DOWNTOWN WEST SUBDIVISION, UNIT SIX, **RESUBDIVISION OF LOTS 21, 22, 23 & 24**

APPLICATION NUMBER 9 DATE November 4, 2004

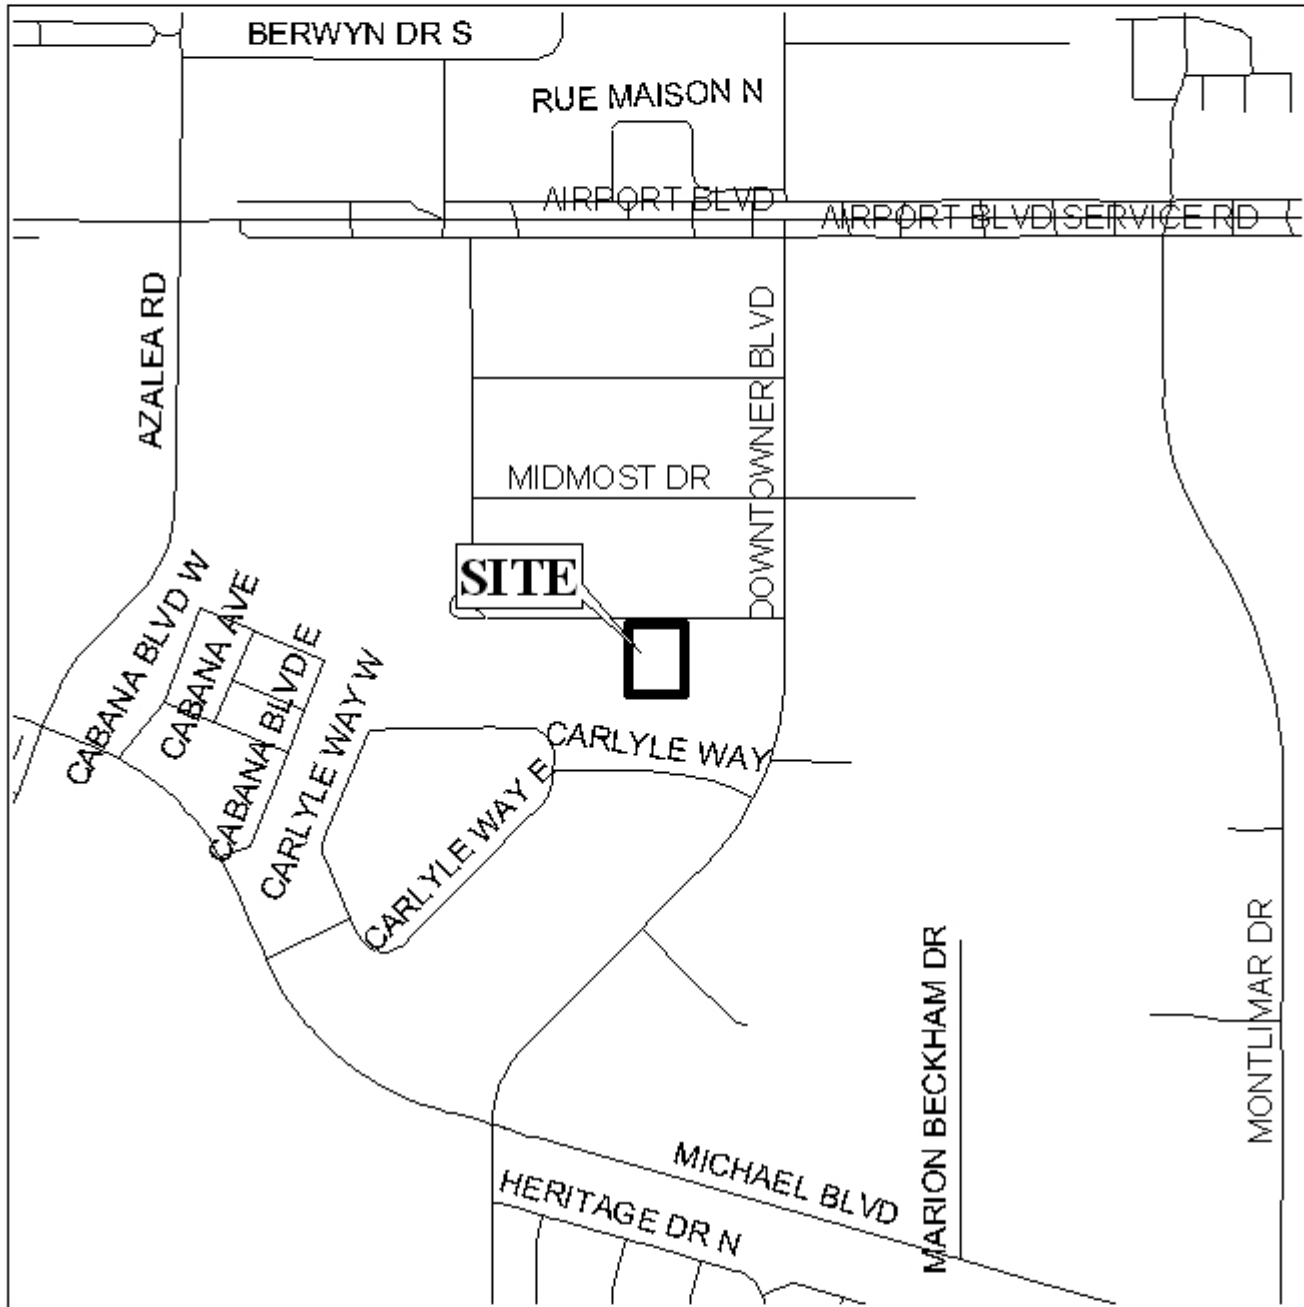
The plat illustrates the proposed 1 lot, 1.6 \pm acres subdivision which is located on the South of Downtowner Loop South, 390' \pm West of Downtowner Boulevard and is in City Council District 5. The subdivision is served by public water and sanitary sewer.

The purpose of this application is to combine four lots into one lot of record.

As illustrated on the Vicinity Map, the site is split-zoned, thus the entire site should be rezoned to one zoning classification prior to the recording of the final plat.

The plat meets the minimum requirements of the Subdivision Regulations and is recommended for Tentative Approval subject to the following condition: 1) that the entire site be rezoned to one zoning classification prior to the recording of the final plat.
